# Illinois Tollway M-ITS Base Sheet Revisions

| Section M | Base Sheet Drawings | |
|---|---|---|
| | **Drawing** | **Modification Summary** **Effective: 2021-03-01** |

**Illinois Tollway Base Sheet Revisions**

| Section M | Base Sheet Drawings | |
|---|---|---|
| | **Drawing** | **Modification Summary** **Effective: 2020-03-01** |

| Section M | Base Sheet Drawings | |
|---|---|---|
| | **M-ITS-1300** | **RWIS Pole, Sensor Mounting Detail** |

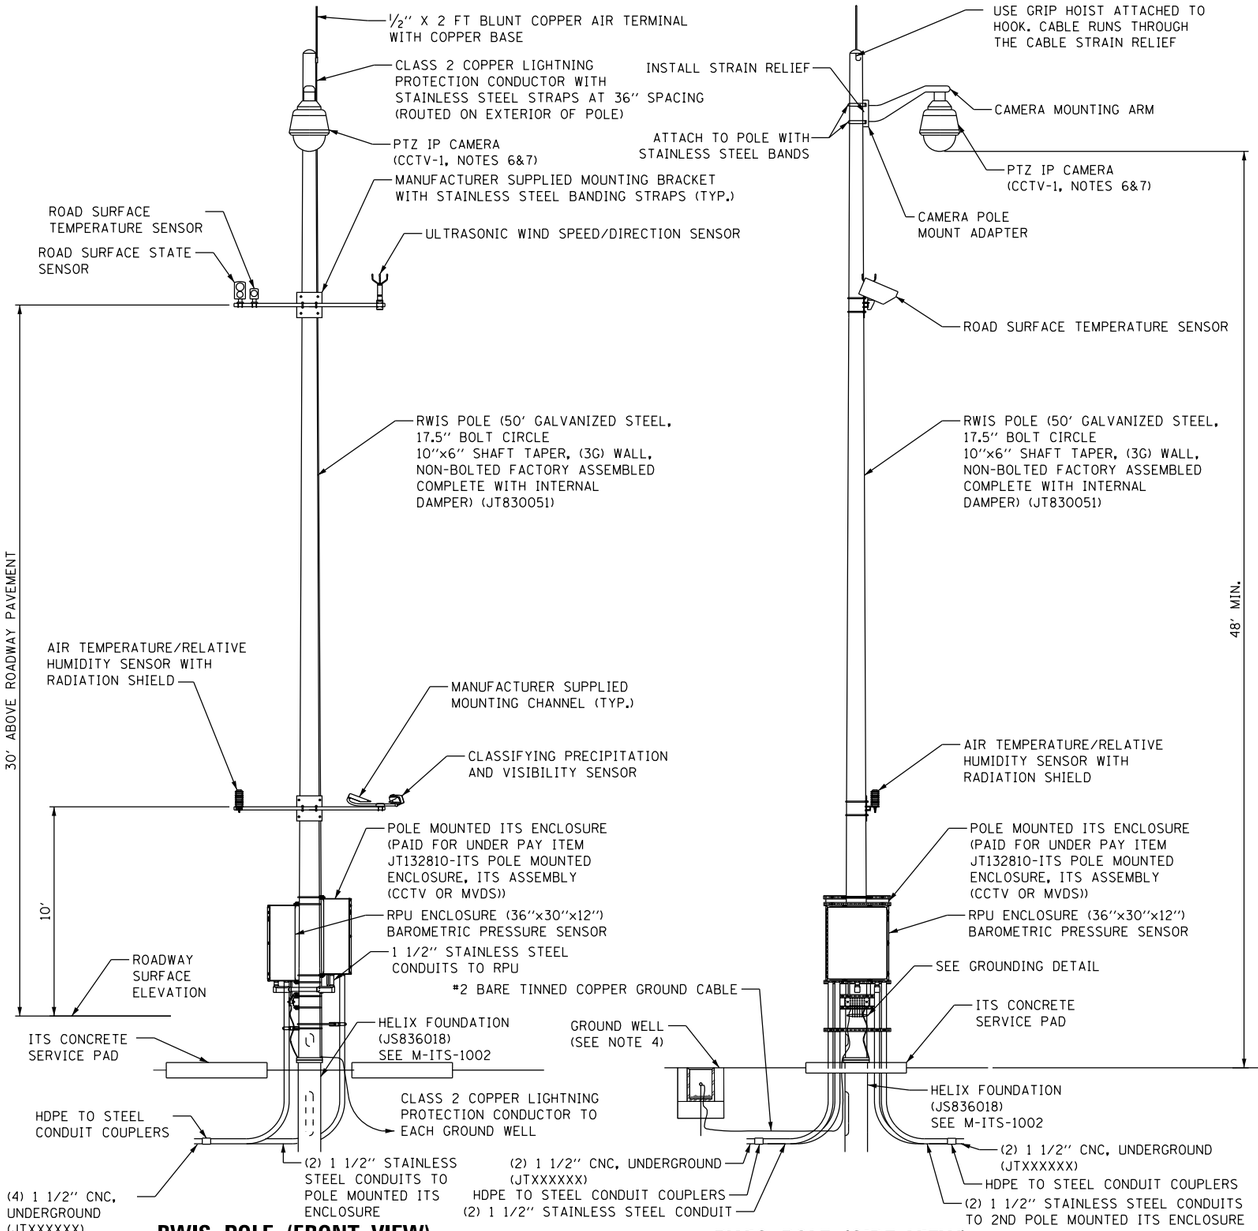
| Section M | Base Sheet Drawings | |
|---|---|---|
| | | . Added Note 8: Wind sensor can be installed on the secondary pole it primary pole is close to tree line<br>. Added Note 9: All cables installed in a pole shall use a grommet to connect to ITS device installed on the pole |

8. WIND SENSOR CAN BE INSTALLED ON THE SECONDARY POLE IF PRIMARY POLE CLOSE TO TREE LINE.
9. ALL CABLES INSTALLED IN A POLE SHALL USE A GROMMET.

| Section M | Base Sheet Drawings | |
|---|---|---|
| | **M-ITS-1302** | **Typical RWIS Site Installation Plan** |

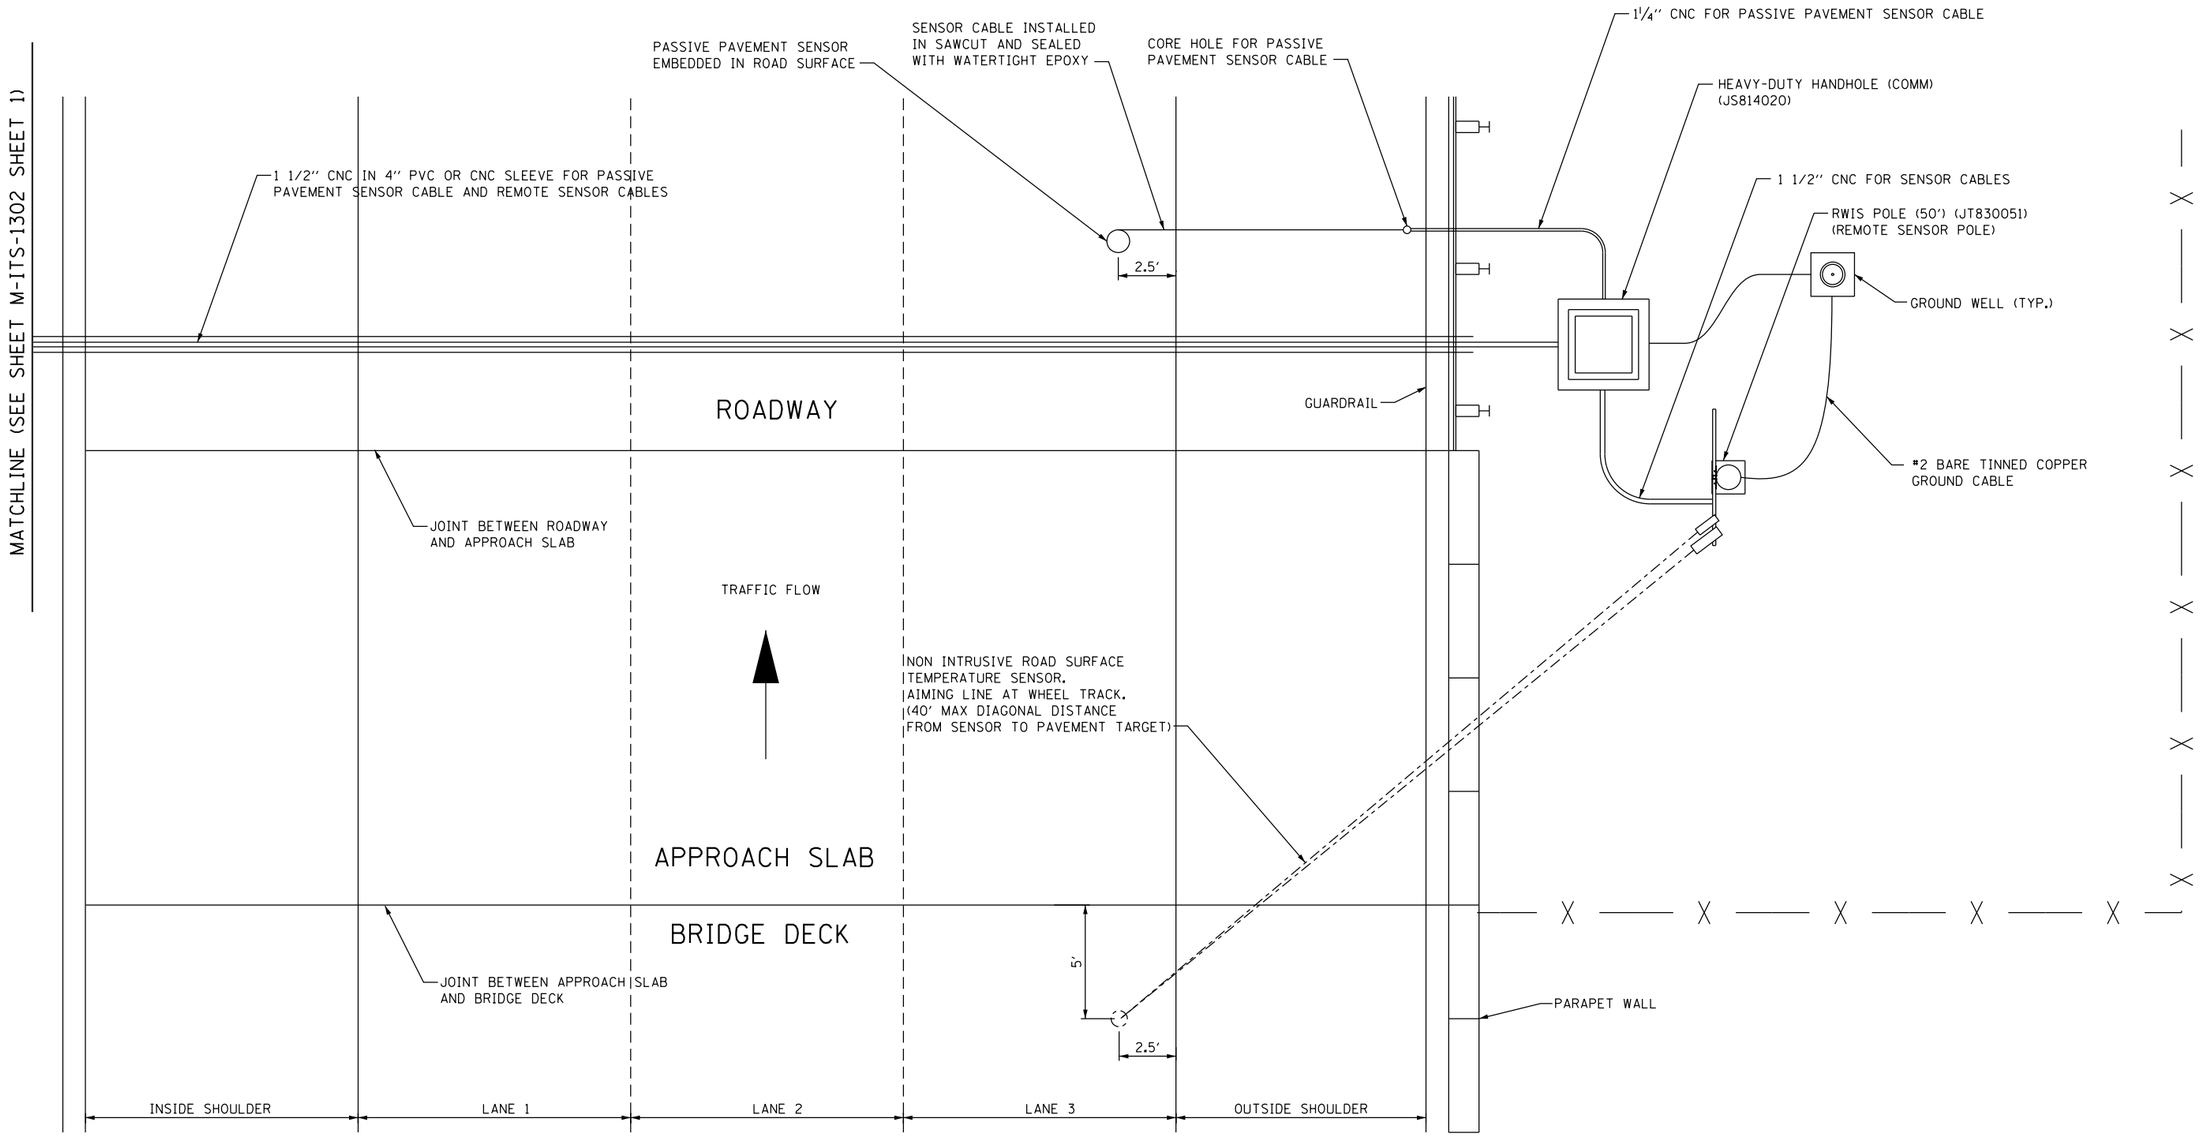
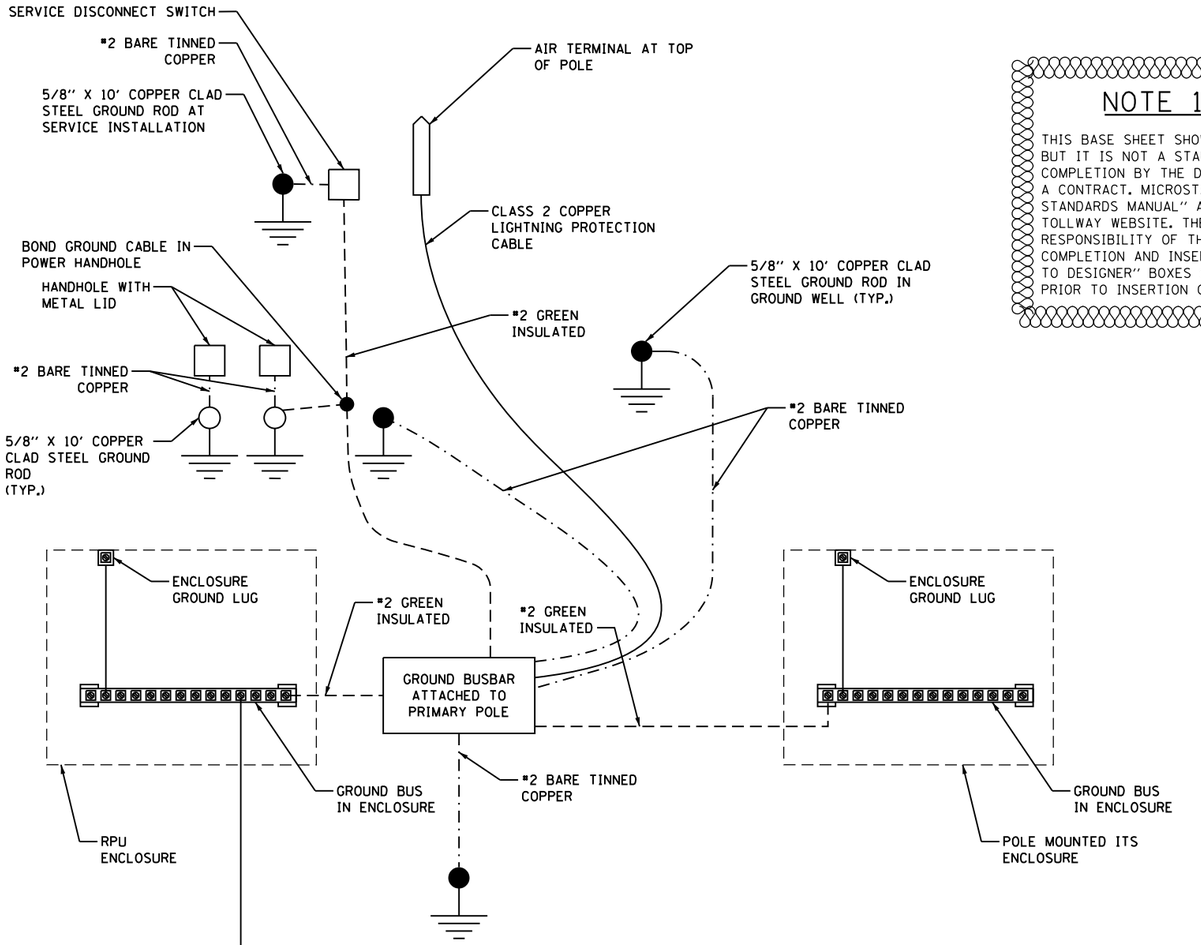
| Section M | Base Sheet Drawings | |
|---|---|---|
| | | . Added Note 5: Note to Designer: In the event the Primary and Secondary poles cannot be installed within the 40 foot maximum radius of the bridge deck, the DSE shall consult with the Tollway and GEC on an alternate placement solution<br>. Added Note 6: Note to Designer: Installation of the Primary and Secondary pole for bridge installation: pole to be installed near immediate entrance of the bridge so non-invasive laser temperature sensor can monitor bridge deck temperature and bridge approach temperature |

IN THE EVENT THE PRIMARY POLE AND SECONDARY POLES CANNOT BE INSTALLED WITHIN THE 40 FOOT MAXIMUM RADIUS OF THE BRIDGE DECK, THE DESIGNER SHALL CONSULT WITH THE ILLINOIS TOLLWAY AND GEC ON AN ALTERNATE PLACEMENT SOLUTION.

INSTALLATION OF THE PRIMARY POLE AND SECONDARY POLE FOR BRIDGE INSTALLATION: POLES TO BE INSTALLED NEAR IMMEDIATE ENTRANCE OF THE BRIDGE SO THE NON-INVASIVE LASER TEMPERATURE SENSOR CAN MONITOR BRIDGE DECK TEMPERATURE AND ALSO THE BRIDGE APPROACH OR DEPARTURE.
